# RECORD OF MEETING

**Client:** City of Taunton **Date:** 05/17/19  
**Meeting Date:** 05/17/19 **Prepared By:** Mike Andrus  
**Meeting Location:** Taunton DPW **Job Number:**  
**Meeting Topic:** Industrial Park Drainage

This meeting was a follow up to a previous meeting and a site walkthrough to determine what repairs, etc. the City wishes to have completed by the TDC prior to the City taking possession and responsibility for the drainage system within the Myles Standish Industrial Park. Requested work has been shown, where available, on attached plans in red.

29-30  
N/F  
ROMJEM LLC  
BASIN #4  
1" = 80'

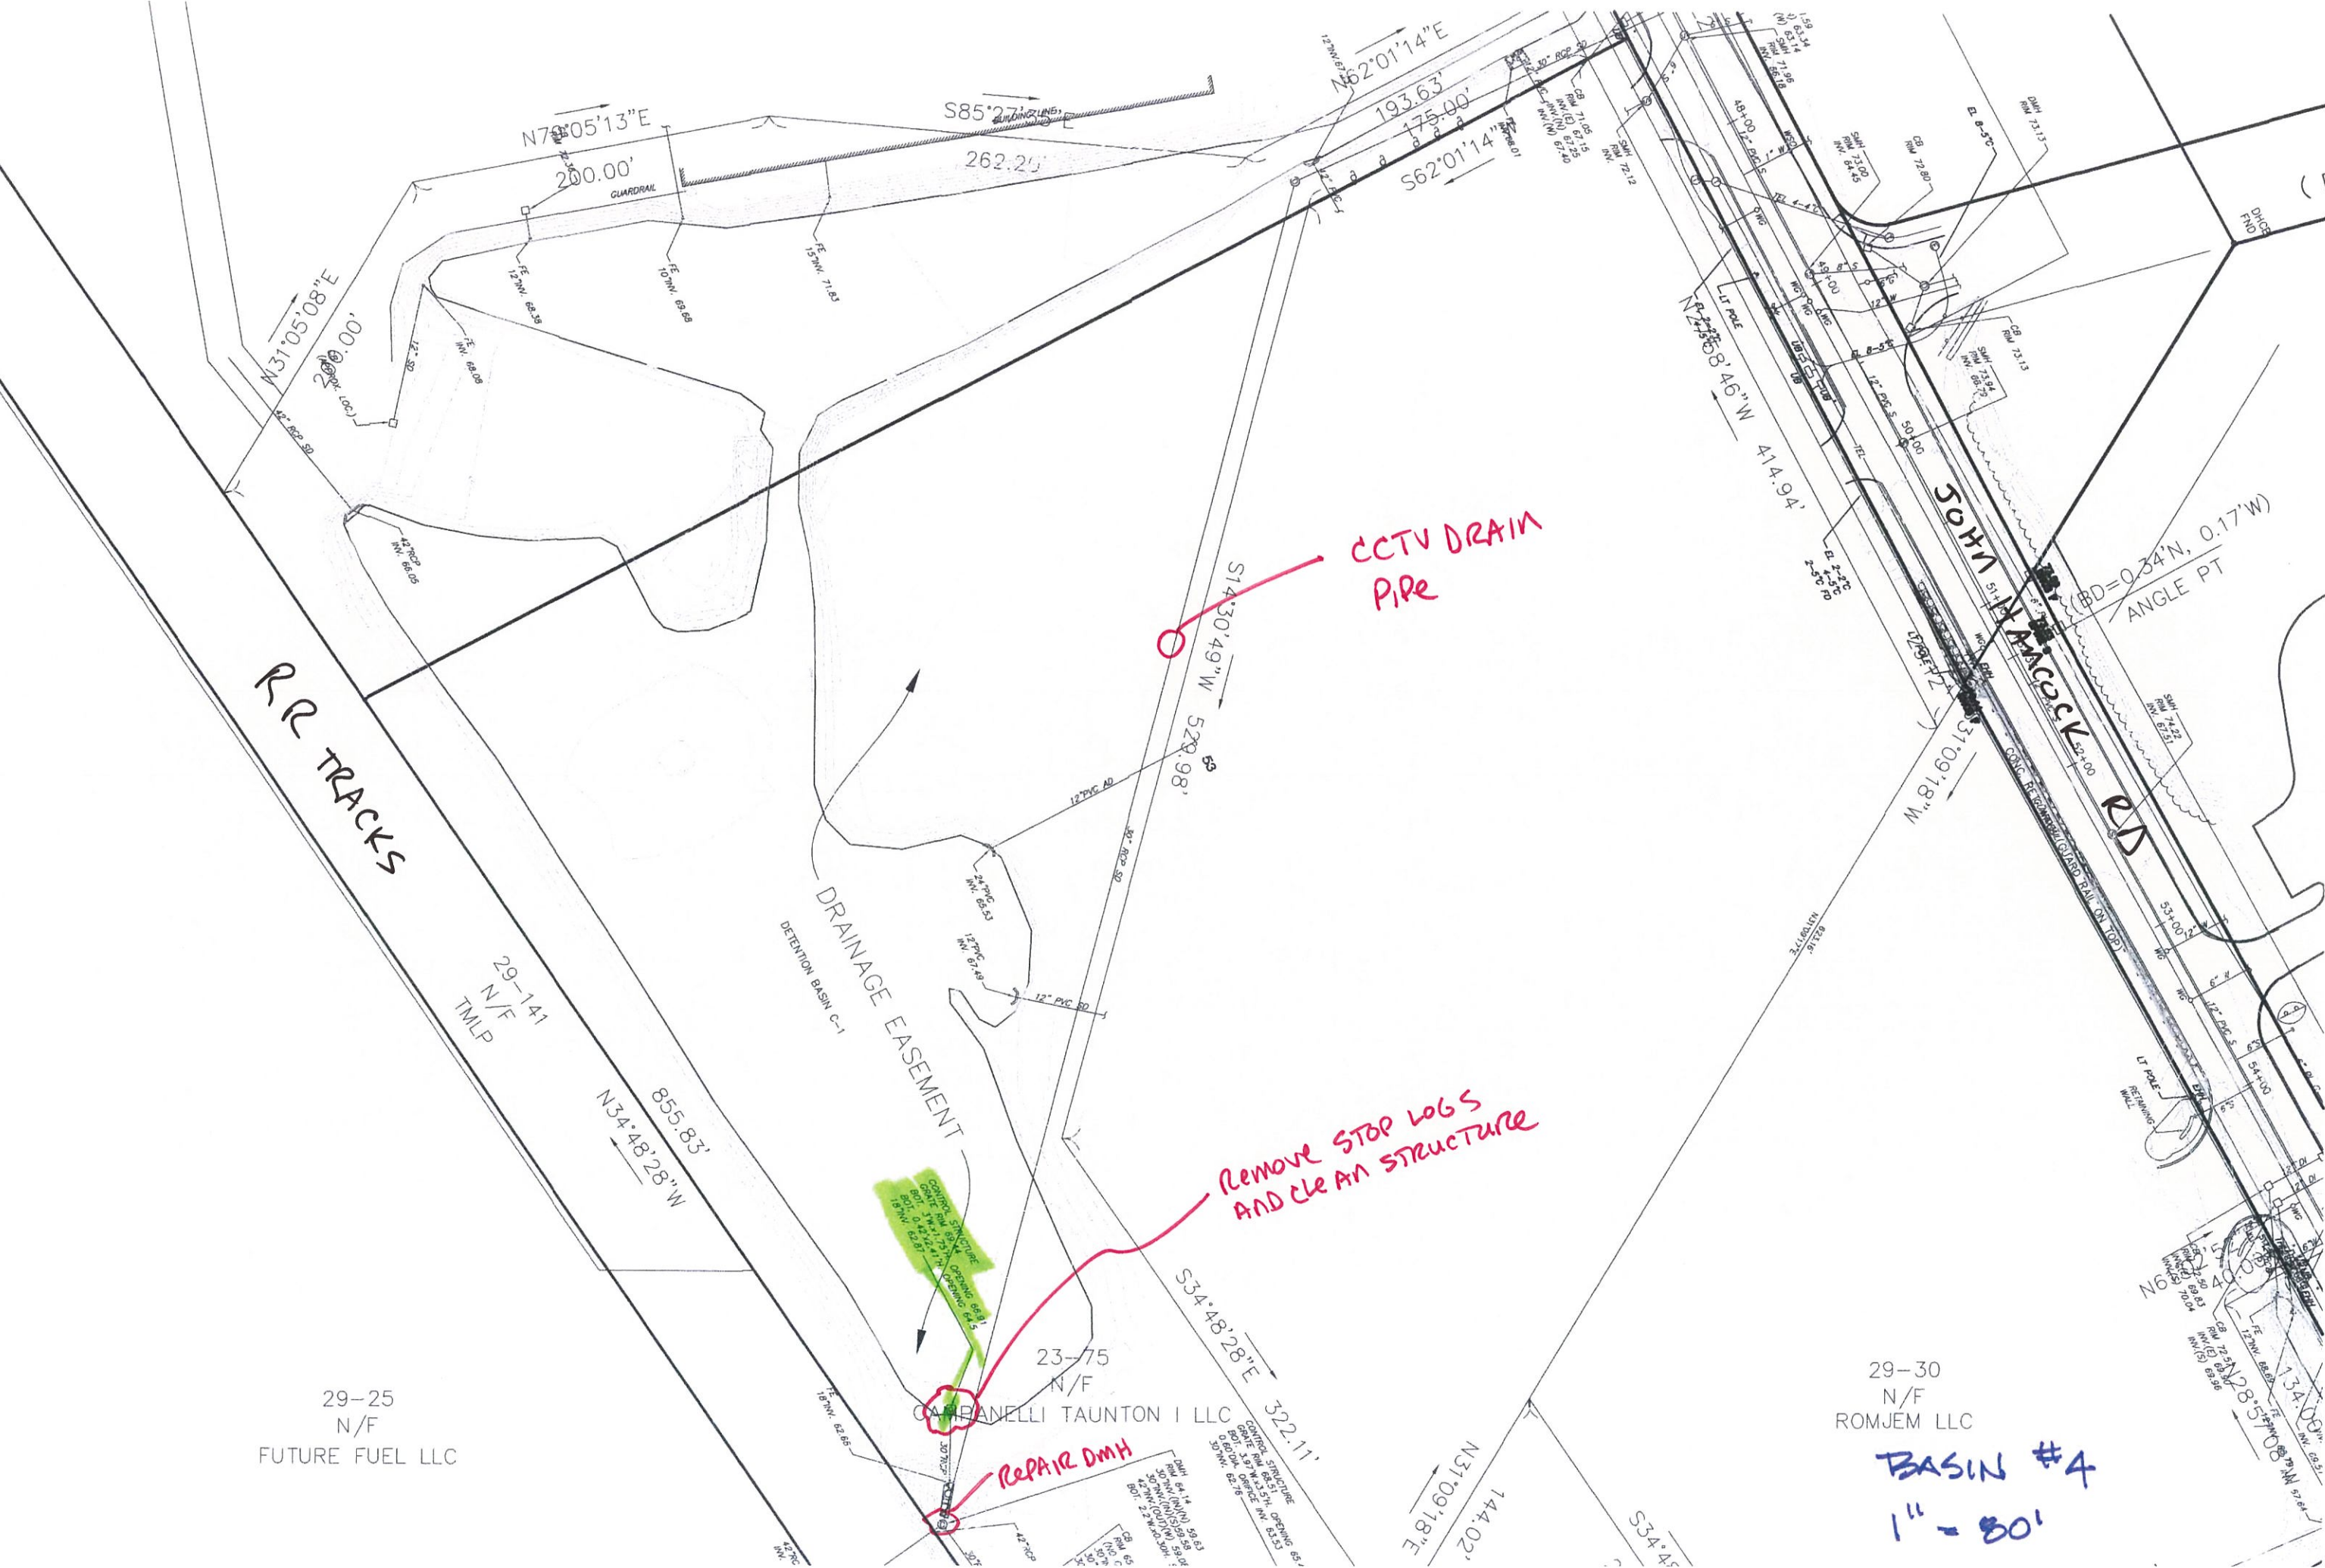
- IV. Basin #4 (John Hancock Rd)
  - A. Pipes under driveways on West Side of Hancock all plugged with soil and mulch, system needs cleaning to get flow into Basin #4

- B. Headwall at outlet of Basin #4 needs cleaning of trash, brush, and debris.
  - C. Remove stop logs from control structure from Basin #4
  - D. Drain structures at outlet of Basin #4 (near RR tracks) need cleaning repair

- E. Investigate condition of drain pipe between John Hancock Rd and Basin #4
- V. Basin #5
  - A. No work needed
- VI. Prince Henry Drive (#6A & 6B)

CCTV DRAIN PIPE

REMOVE STOP LOGS AND CLEAN STRUCTURE

REPAIR DMH
